August 1, 2018

**DEP FILE E02-1773**  
**Falcon Ethane Pipeline System**  
**Response to Technical Deficiency Letter — Allegheny County**

On behalf of Shell Pipeline Company LP (SPLC), AECOM Technical Services, Inc. (AECOM) has prepared the following responses to the PADEP comments dated June 1, 2018. AECOM is submitting two hard copies and two electronic copies of this comment/response letter and revised documents for the Falcon Ethane Pipeline System (Project) per the discussion held with PADEP, SPLC, and AECOM on June 1, 2018. Please add/replace these documents in your existing hard copies. Per previous discussion with Josh Shaffer at the Army Corps of Engineers (Corps) and with respect to the Corps' effort to reduce paper, the Corps' copy of this comment/response letter will be uploaded to the Corps' SAFE file upload site. The technical deficiency letter, as requested, is included with this submission as Attachment A.

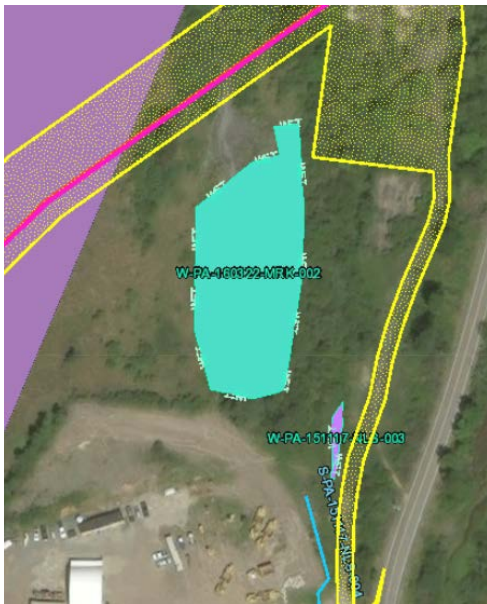
they are EV. A one-half-mile-buffer was established based off the northern harrier survey area (see the screenshots below). The wetlands within the limit of disturbance (LOD) and adjacent (less than 50 feet from the LOD) was chosen due to a lack of definition for adjacent) within this buffer were examined to determine if they are EV.

In the first screen shot below, the purple polygons represent the avian survey areas as defined by PGC and the shaded white areas represent the buffer around the polygons. The red line represents the Falcon centerline. In the second screenshot, the orange lines represent the same buffer as in the first screenshot, the pink lines represent the Falcon LOD, and the green polygons represent delineated wetlands.

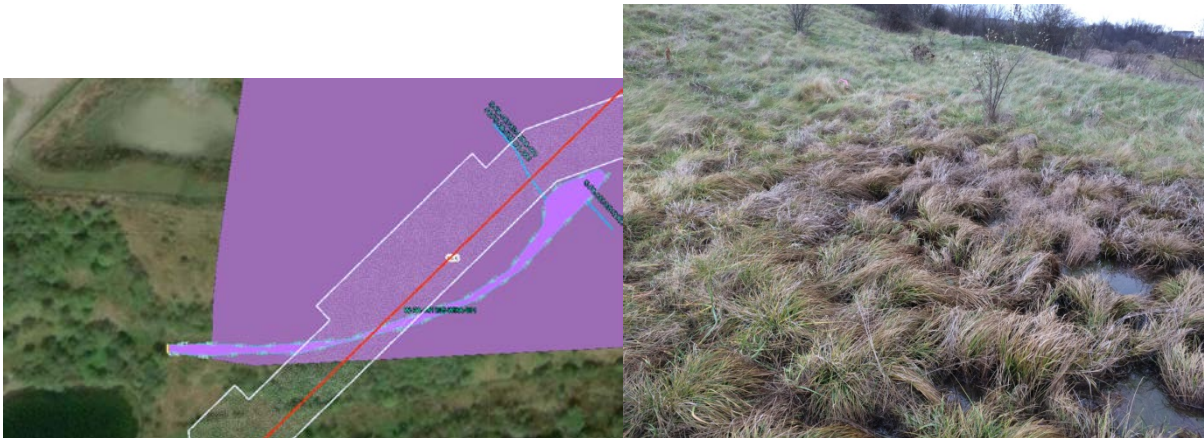
**W-PA-161205-WRA-001** is a PEM wetland located within reclaimed strip mine. It is located in an open area and contains sedges and fescue which is thick vegetation that would be suitable for NOHA nesting. Given that NOHA may nest here—although they are not currently nesting here—this wetland could be considered EV.

In the event that a NOHA would utilize this area for nesting, it would not be disturbed due to the time-of-year construction restriction placed on this area from April 15<sup>th</sup> through August 31<sup>st</sup>.

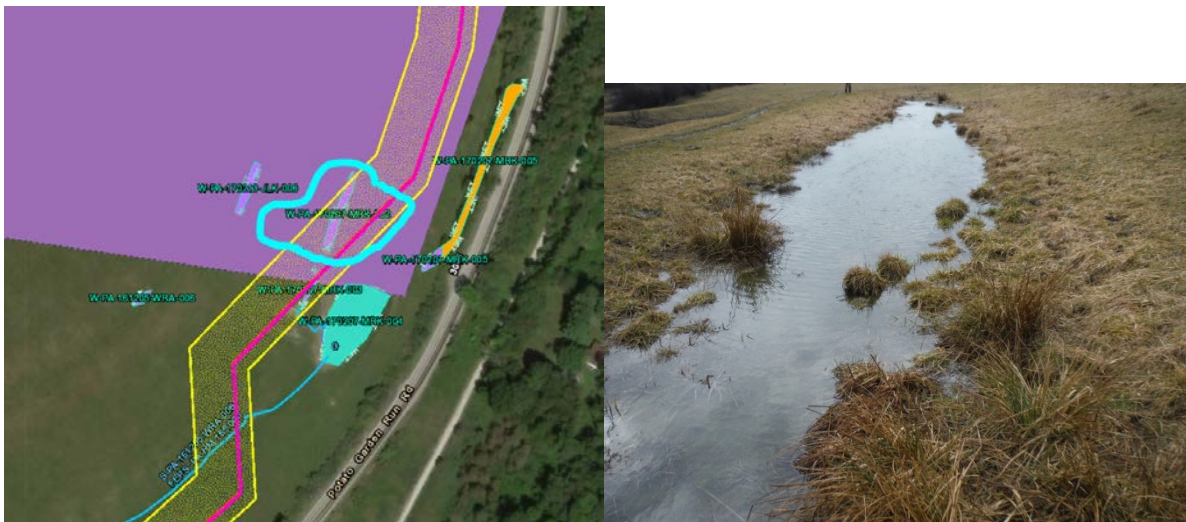
**W-PA-170207-MRK-001** is a PEM wetland located within reclaimed strip mine habitat. The wetland is located within an open area and contains hummocky thick vegetation which would be suitable for NOHA nesting. There was approximately one inch of groundwater present; however, this appears to be a groundwater-fed wetland and it does not receive overflow from adjacent resources; therefore, it would most likely be suitable nesting habitat. As a result, this wetland should be considered EV.

The LOD has been notched out to avoid this wetland. Proper BMPs will be placed so that sediment will not leave the LOD during construction and impact this wetland. If a NOHA would utilize this area for nesting, it would not be disturbed due to the time-of-year construction restriction placed on this area.

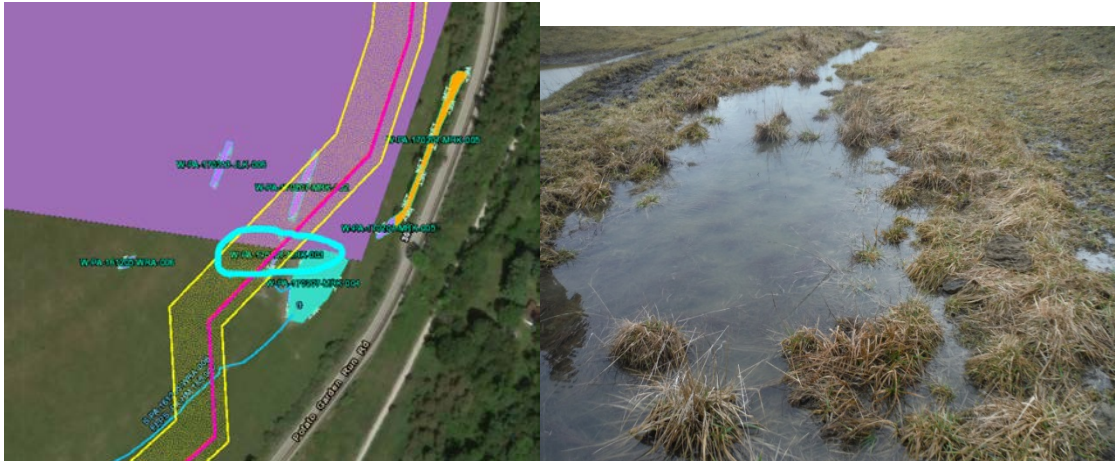
**W-PA-170207-MRK-002** (circled in blue below) is a PEM wetland located within reclaimed strip mine habitat inside a constructed swale/water bar. There was approximately three inches of water present at the time of delineation and only 45 percent vegetation cover; however, this was delineated two to three months prior to the typical nesting period so it is possible that the water could recede, and more vegetation could grow making this wetland more suitable for nesting. The wetland is also located within the area that the PGC determined to be suitable habitat. Given that it is likely that a NOHA could utilize this wetland area as a nesting location, this wetland should be considered to be EV.

**W-PA-170207-MRK-003** (circled in blue below) is a PEM wetland located within reclaimed strip mine habitat. Like W-PA-170207-MRK-002, it was located inside a constructed swale/water bar. There was approximately two inches of water present at the time of delineation and only 45 percent vegetation cover. For the same reasons as stated above for W-PA-170207-MRK-002, it is likely that NOHA could utilize this area for nesting and therefore the wetland should be considered EV.

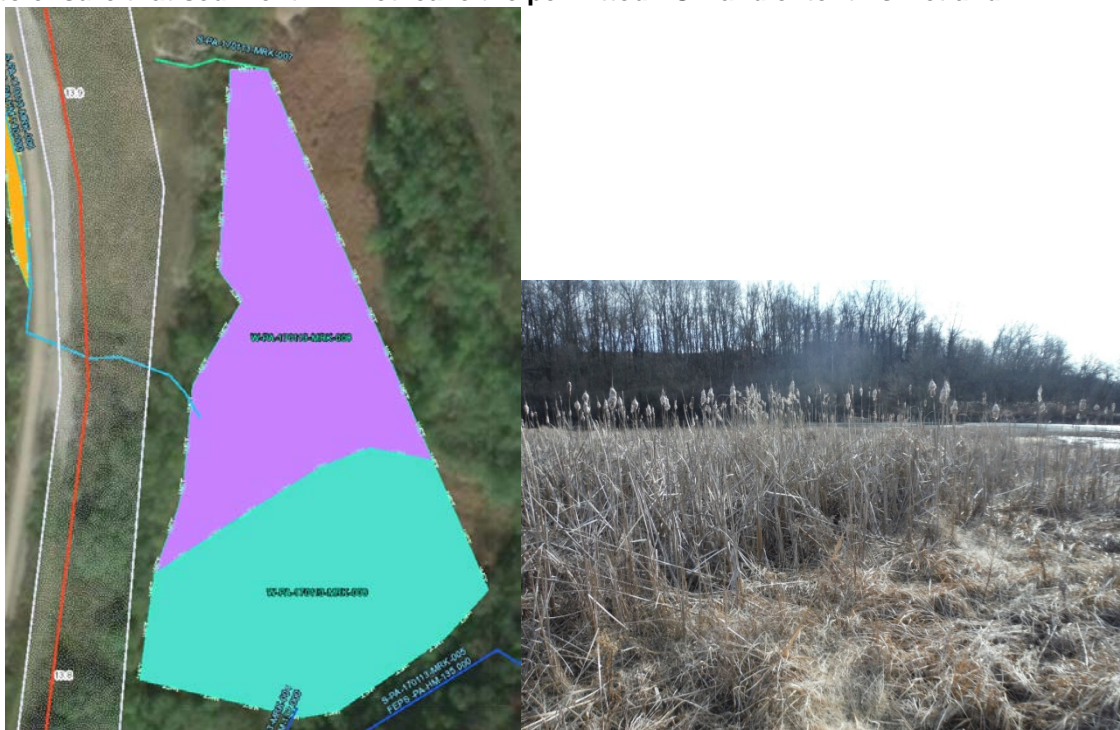
**W-PA-170113-MRK-008** is a PEM/PUB complex located along the Montour Trail. There may be too much disturbance in the portion of the wetland close to the trail. However, the vegetation is very thick, and it might be suitable nesting habitat on the eastern edge of the wetland. As a result, this wetland could be considered EV.

The Project will not impact this wetland. Proper BMPs such as silt sock or fence will be installed to ensure that sediment will not leave the permitted LOD and enter this wetland.

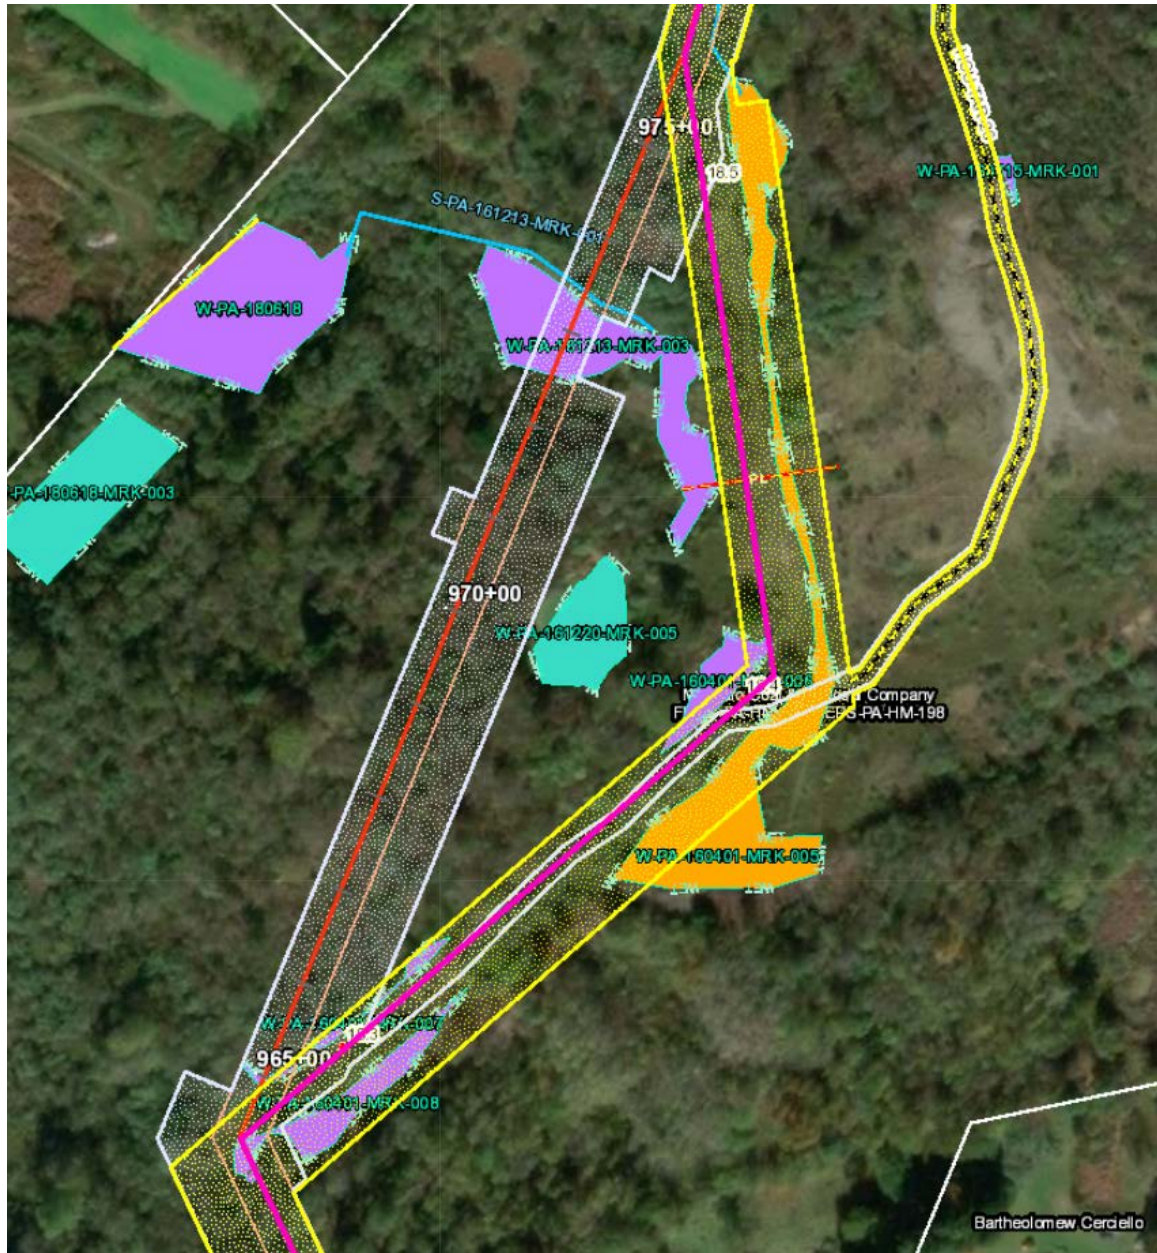
b. Adjusting route to avoid or minimize impacts at RC-20 to RC-24.

The landowner was contacted, and he was amenable to shifting the route slightly west. This resulted in:

- The PSS wetland W-PA-160401-MRK-005 will still be impacted; however, it will only be impacted by a temporary access road, and it will be impacted 15,086 ft<sup>2</sup> less than what was originally proposed.
- W-PA-160401-MRK-008 will be impacted 5,242 ft<sup>2</sup> less.
- W-PA-160401-MRK-006 will no longer be impacted.

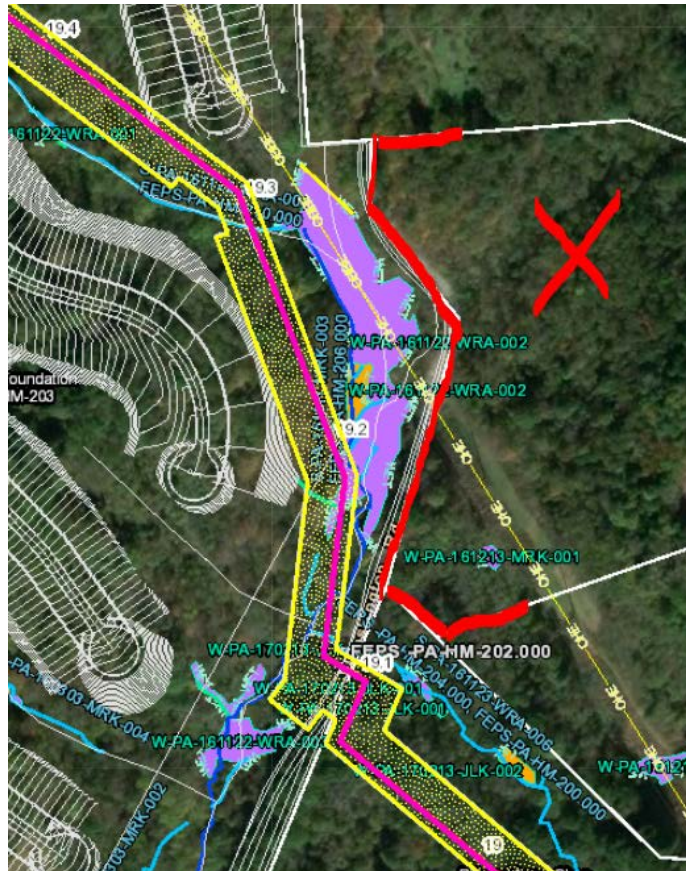
- d. *Adjusting route at RC-28, so that the proposed pipeline crossing is at a right angle, to minimize impacts.*

This is the only location possible for the LOD. The property outlined in red originally was going to allow the pipeline to go through their property; however, they later denied access, which shifted the pipeline west. The white lines in the screenshot below represent the LOD of a proposed housing development. The purple polygon is a large wetland/stream complex. The developer originally wanted the pipeline to travel through the wetland complex; however, SPLC was able to negotiate out of it as much as practicable without interfering with the housing development.

**SPLC approached the landowner to see if the line could be shifted to reduce the watercourse impact. The landowner is a developer that has plans for this property and wanted the route where it currently is proposed. SPLC has approached him to see if he would be amenable to a reroute; however, this may be unlikely. In the event that he accepts a reroute, SPLC will send an update to the PADEP.**
